**PLANNING COMMISSION AGENDA ITEM**  
CITY OF SHORELINE, WASHINGTON

**AGENDA TITLE:** Continued Public Hearing on Town Center Subarea Plan and Development Code  
**DEPARTMENT:** Planning and Development Services  
**PRESENTED BY:** Joseph W. Tovar, FAICP, Director  
Paul Cohen, Senior Planner

As a follow up to the June 2 meeting, staff prepared a series of edits and revisions for the Commission's consideration as amendments to the Town Center Development Plan and Development Code. The amendments, in Attachments 3 and 4 are highlighted in color for your reference and to reflect their genesis:

Figure 1. 20.92.020

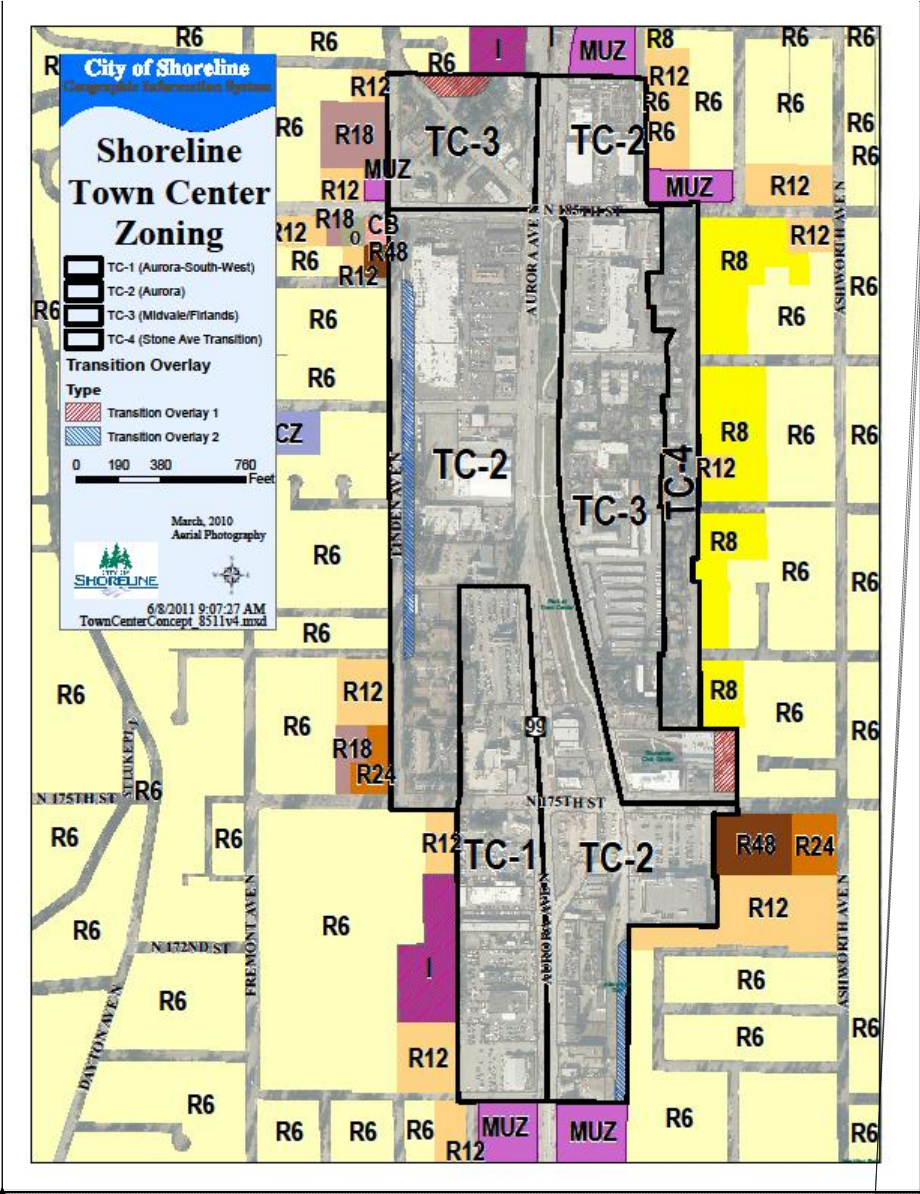
- Comment [p5]: SE Corner -Transition Overlay 2 needs to be adjusted west off SCL.
- Comment [p6]: New Map with Transition Overlays 1 and 2
- Field Code Changed

2. **Transition Overlays 1 and 2: These is-overlays provides a-transitions from** higher intensity development to lower intensity uses and protects ~~adjoining~~ single family neighborhoods from large building heights, traffic, and inappropriate land uses.

**20.92.030 Street Types and Pedestrian Circulation.**

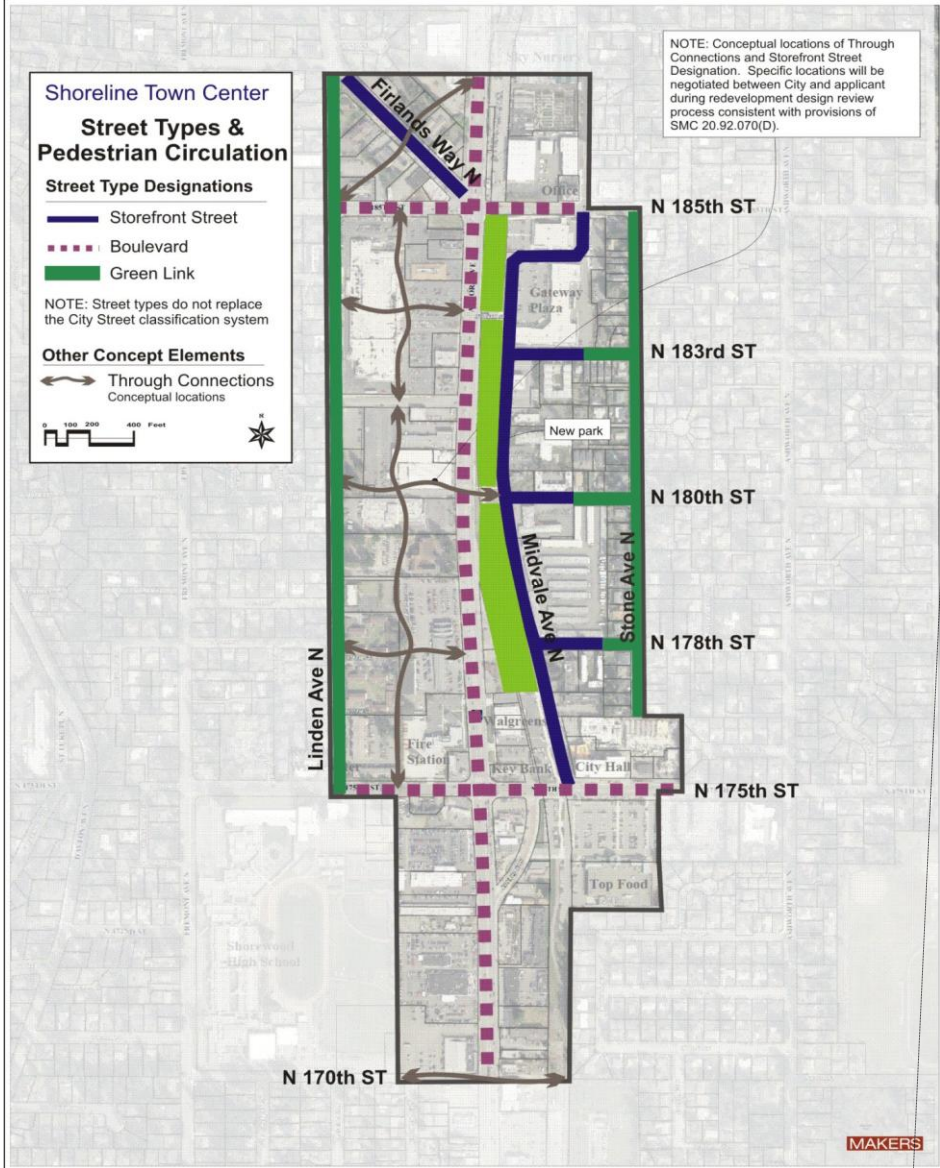
Comment [p14]: Will be revised to extend Storefront Streets to Stone Avenue. Mid-block street abutment of two different street sections do not work.

# Transition Overlay 1

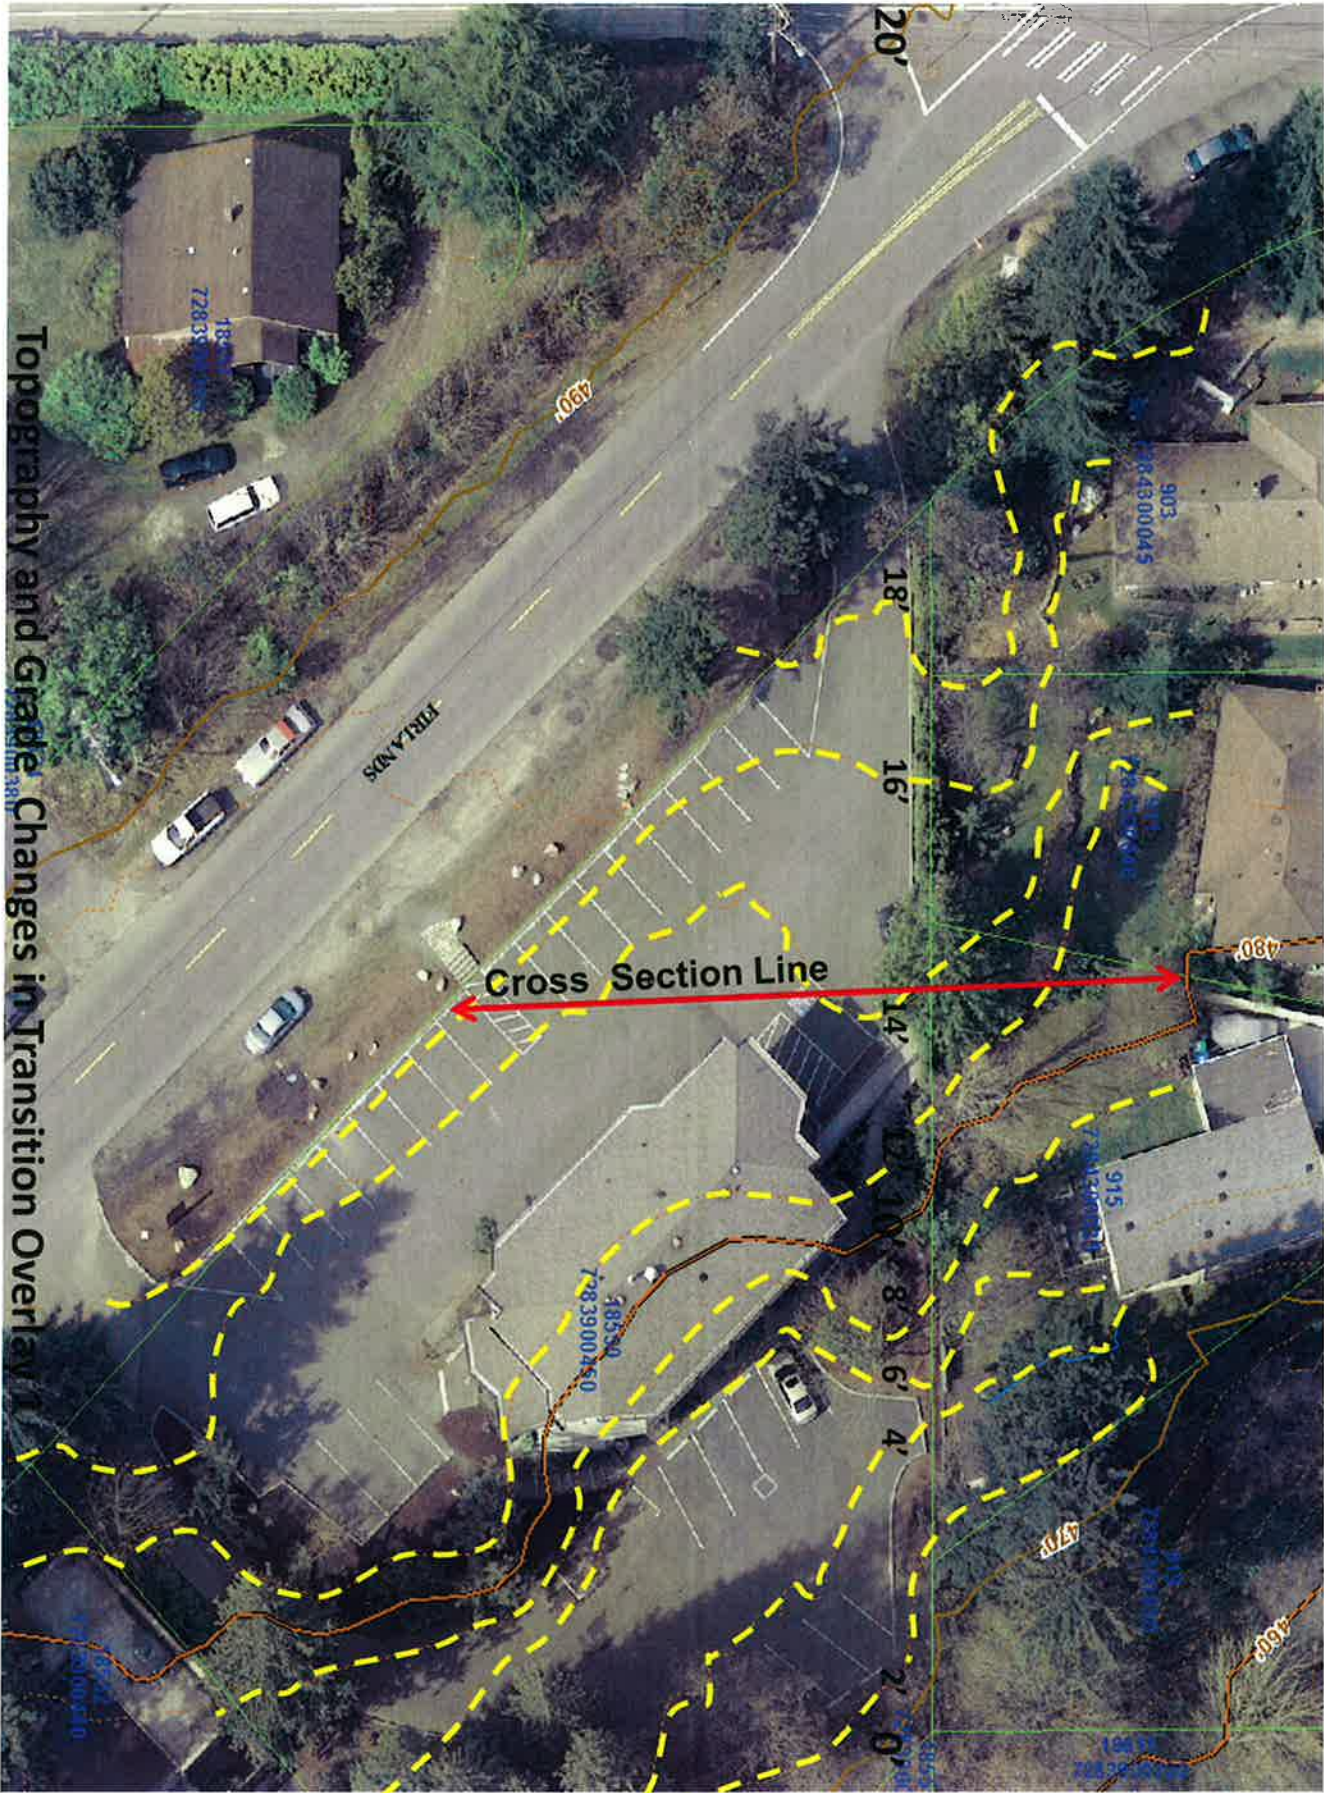
Attachment 4 - *REVISION* to Transition Overlay #1 Site Plan and Cross Section (Exhibit 22)

2. Transition Overlay 1 is 100 feet wide and from adjoining R-4 or R-6 zoned property lines. From the adjoining property line it requires 20 feet of Type I landscaping and building setback with a maximum height of 35 feet for the next 30 feet and then additional 10 feet of building height for each additional 20 feet of setback until the maximum building height of the underlying zone is obtained.
